**ROUND HILL ROAD RECREATION AREA
SALEM, CONNECTICUT**

Report Date: July 1, 1991

**Environmental Review Team
Report #492**

LONG RANGE PLAN

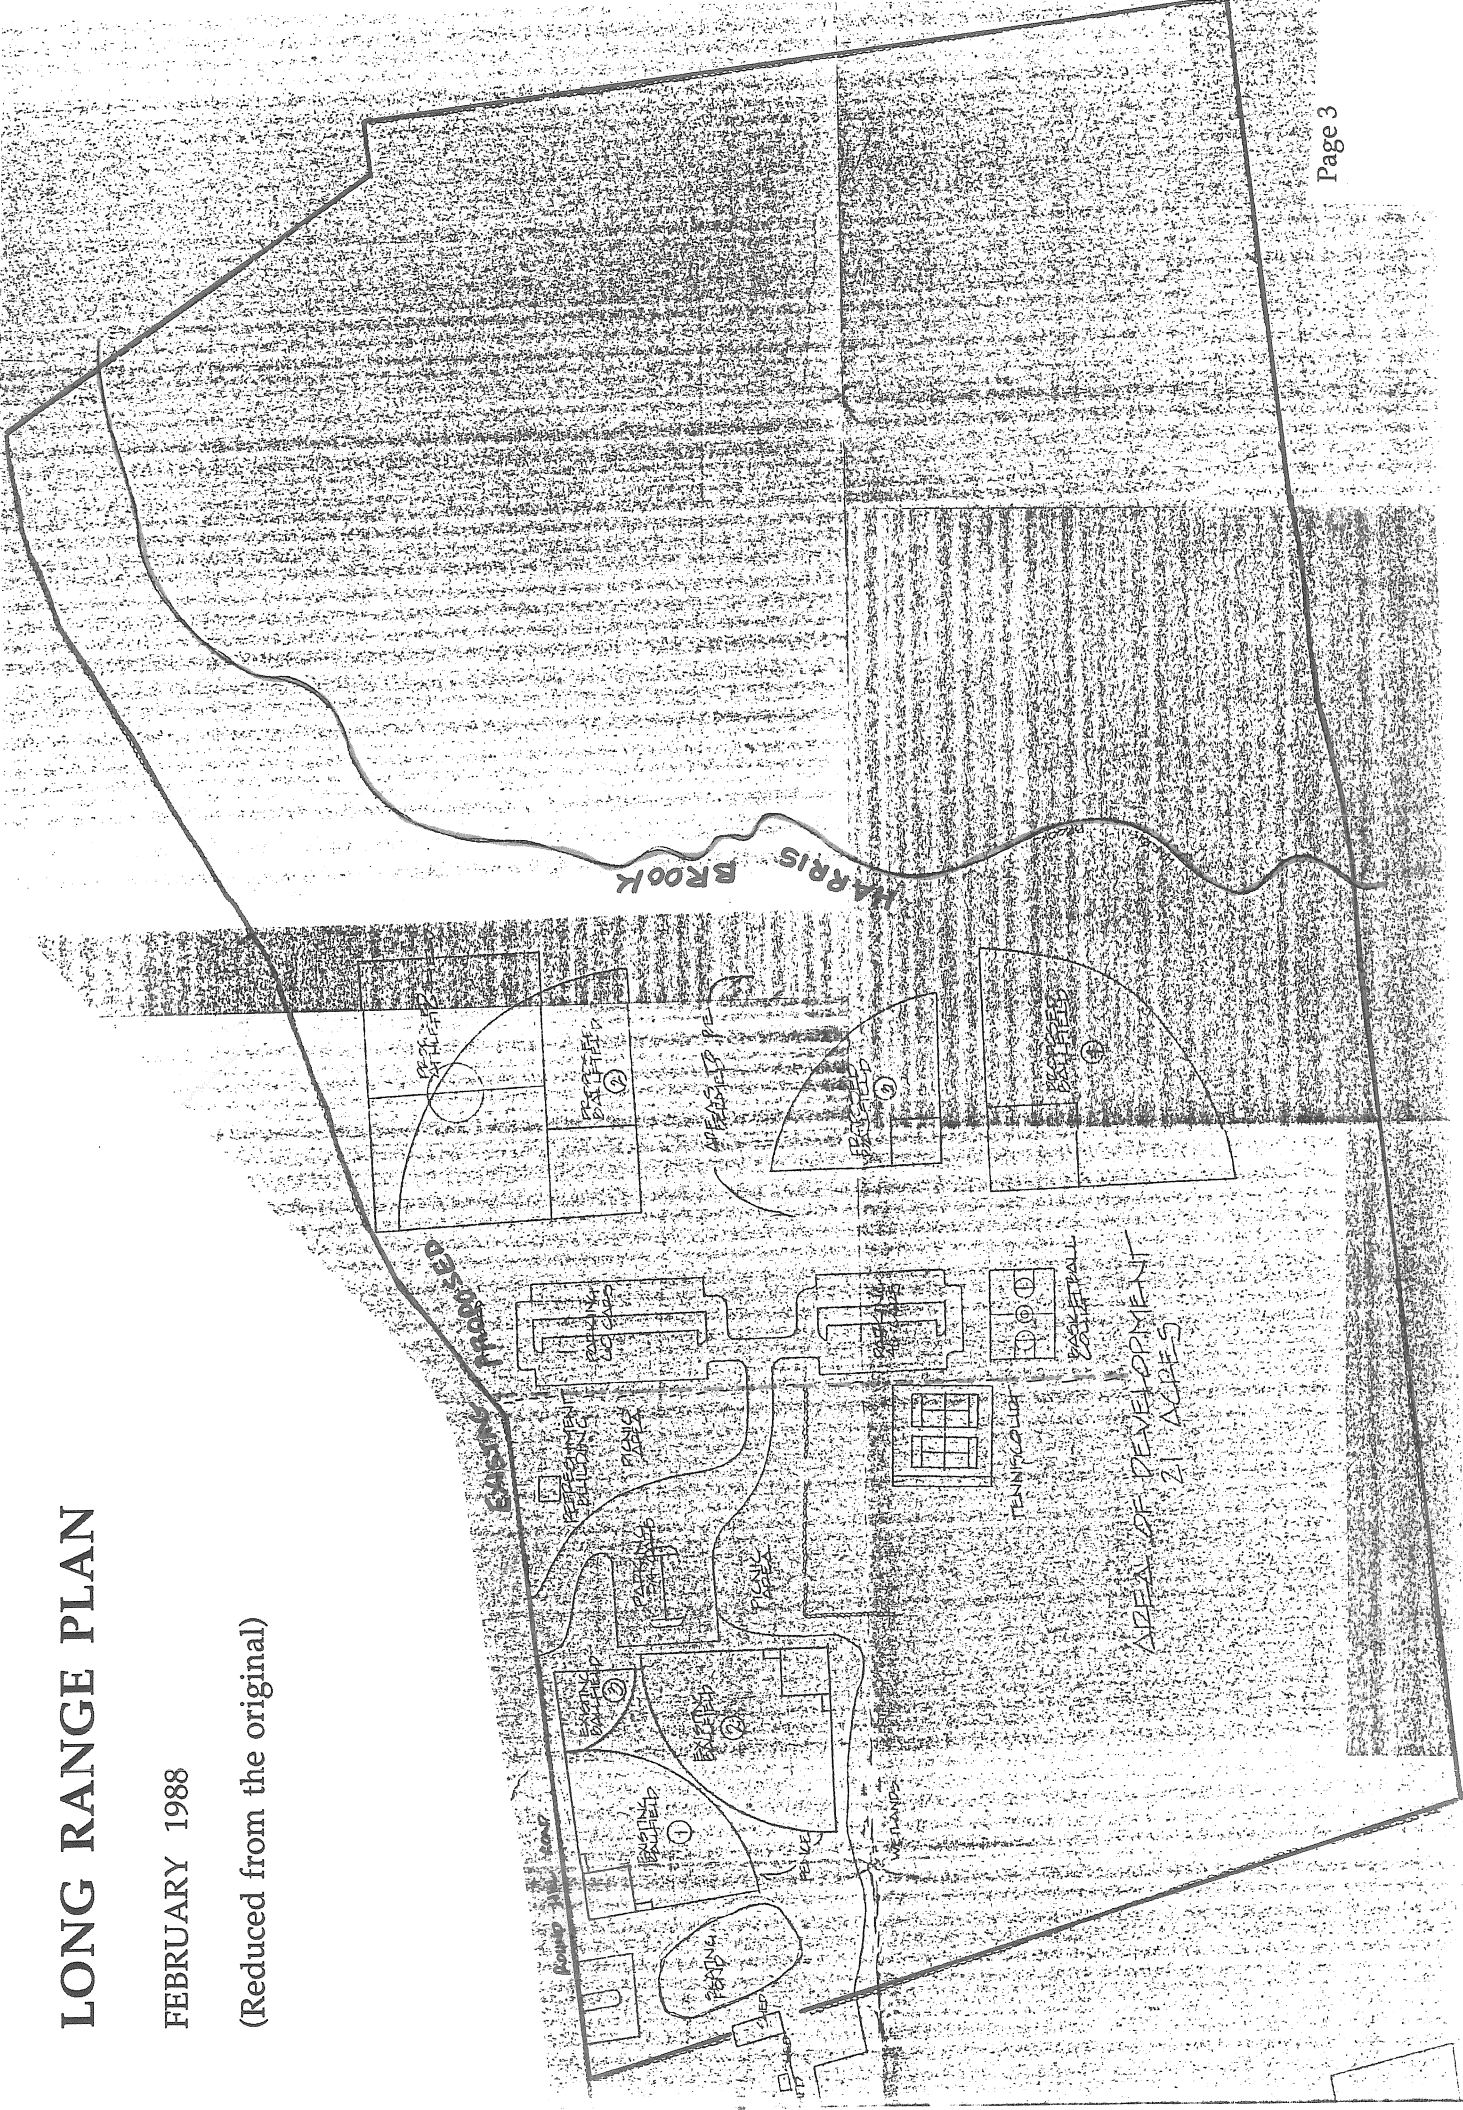
The facilities at the Round Hill Road Recreation Area are basically very handsome with well developed ballfields and tennis courts for a community of this size and despite the naturally stony character of the site. The Park Planner's only major question relates to field #3, which seems too small to be useful. Also, the close proximity of fields without a buffer strip may pose a safety hazard from home runs landing in adjacent fields. In the Park Planner's view there is no problem in filling the skating pond if parking is needed in that location and developing a new pond further to the south along the same swale. (*Please see Wetland Review section and Fisheries Resources section for additional opinions and comments on this issue*) It was noted that the picnicking area shown as existing immediately south of the refreshment building shows no sign of development as such.

- 1.** The proposed combination ballfield/athletic field east of the Recreation Building is not feasible because it is largely located in an inland wetland.
- 2.** The proposed parking area between the Recreation Building and the proposed combination ballfield/athletic field will pose development problems and likely substantial expenses because of slope and the need to regrade the site.

3. The proposed ballfields, basketball courts and parking area east of the existing tennis courts seem feasible although stoniness will be a factor and some regrading will be necessary.

4. The poorly drained streambelt along Harris Brook which includes a former beaver dam should be retained intact providing some fishing opportunity.

5. The hilly upland east of Harris Brook should remain as is; as a natural component of the park. Because of the prevailing width of the Harris Brook wetland, trail access to this area from within the park will be difficult to develop requiring a bridge and boardwalk/bog bridge. This issue deserves further analysis. ↗
